**A RESOLUTION OF THE PLANNING COMMISSION OF THE CITY OF SISTERS,
STATE OF OREGON PLANNING COMMISSION RESOLUTION PC 2020-01**

WHEREAS, Threewind Partners, LLC (the “Applicant”) filed an application for a master, which were assigned Planning File No. MP 19-01 (the “Application”);

**EXHIBIT A
ADOPTED FINDINGS**

Figure 2. Primary Local Street Connections

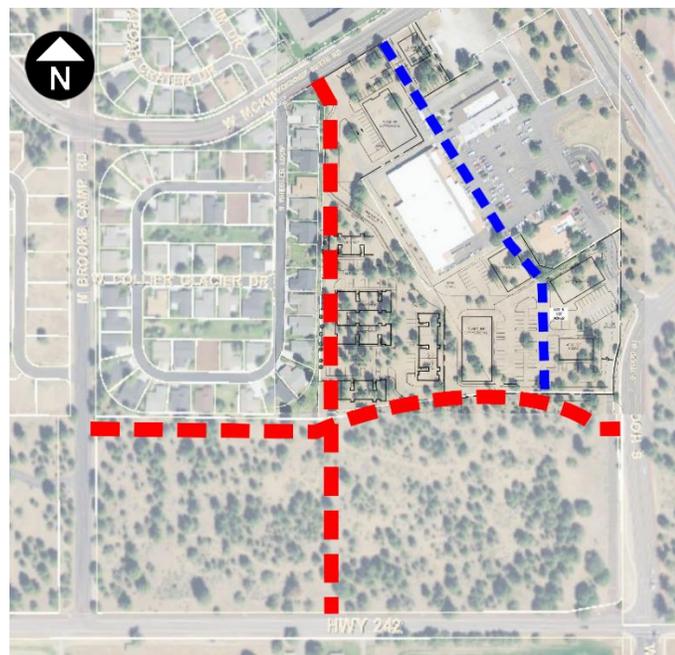
A separate north-south drive aisle connects the southern edge of the site north to McKinney Butte Road. As shown, if a motorist were to follow this drive aisle they would end up at a one-way alley as the primary route is unclear. As shown the current site plan maximizes the development potential of the site but makes the site circulation confusing for motorists. The drive aisles should be designed in such a way that it is clear to the motorists how to enter and exit the site and should define the main drive aisles to avoid mixing main travel routes with parking maneuvers. Minor changes could be provided to form this internal local “spine” system for ease of wayfinding. The connections do not need to be straight as shown in Figure 2, but drivers should not be forced to turn to maintain this route.

A potential layout for the area is shown in Figure 2, where the local road connections to McKinney Butte Road and Hood Avenue serve as the main drive aisles. Parking aisles or apartment driveways can be connected to these roads to serve the adjacent developments. This layout meets driver expectations and supports area connectivity needs.

Figure 3. Site Layout Comments

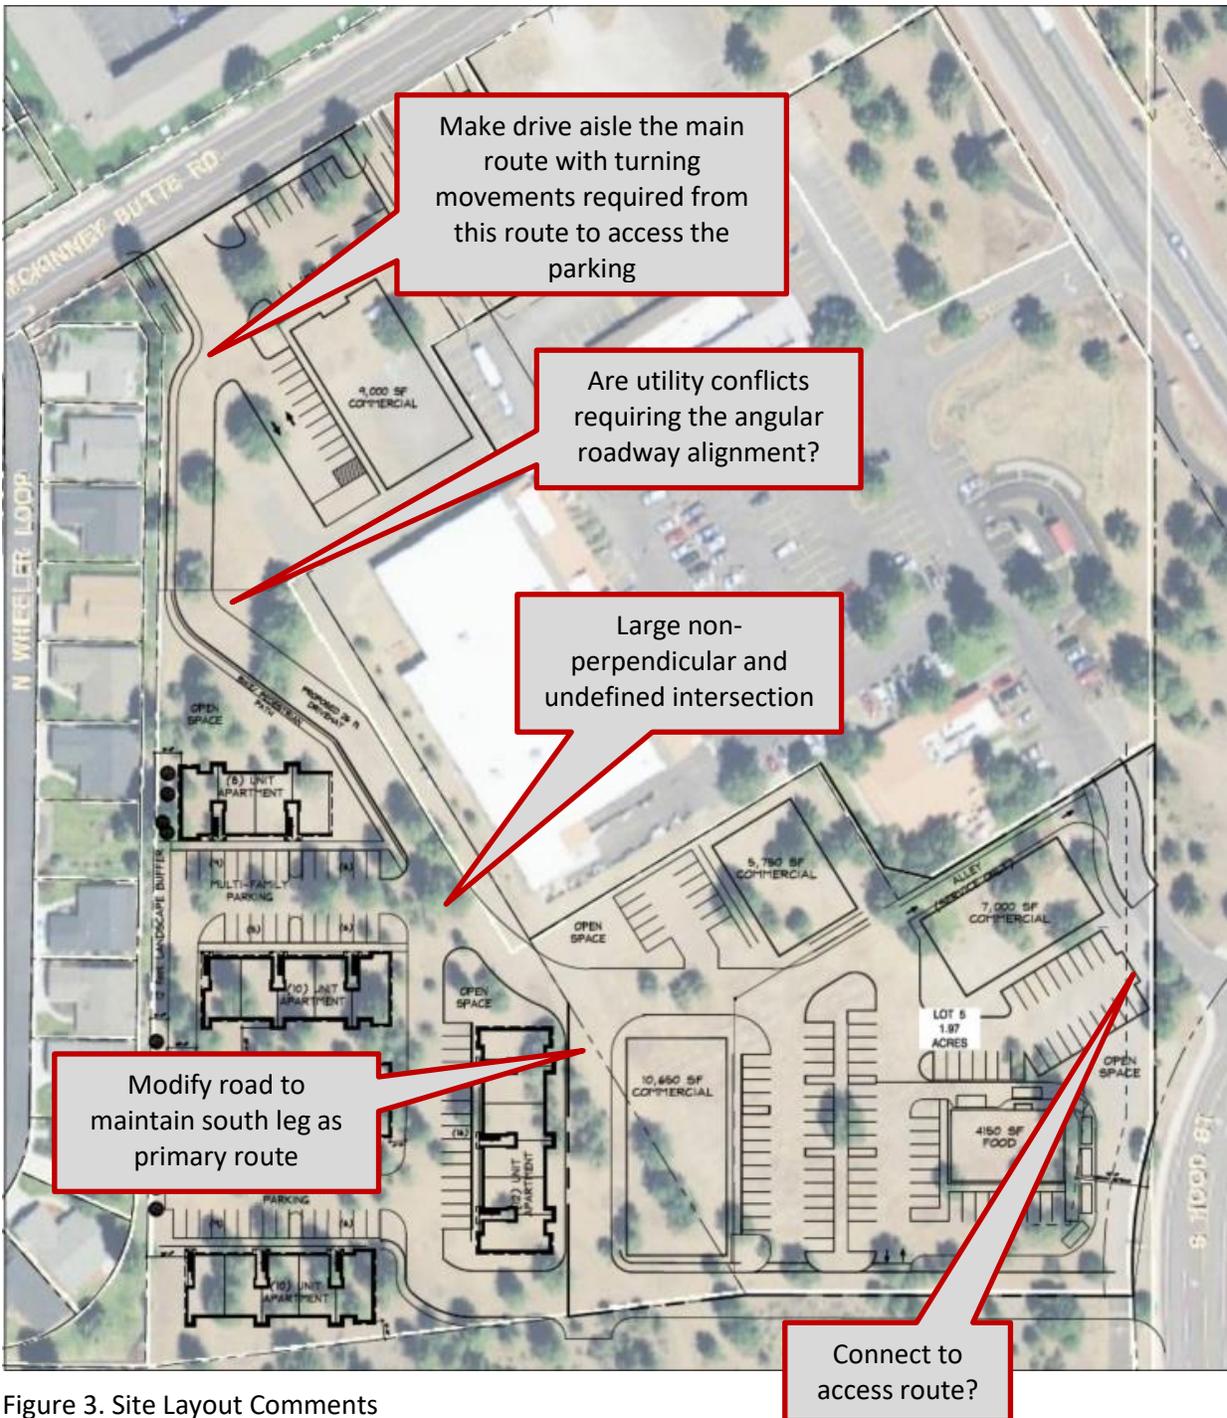
Within the layout it is critical that intersections occur with perpendicular (or nearly perpendicular) angles to maximize driver views, and that intersections that are large and undefined be avoided. Figure 3

highlights some of the intersections of concern within the current site layout. These types of intersections make it unclear where motorists should position or where they are turning. This leads to driver confusion, site congestion, longer pedestrian crossing distances, and can make travel conditions less safe.

Figure 3 also shows a drive-through food use in the southeast corner of the site with a drive-through lane that extends around the building. This layout provides no storage depth near the access onto the new
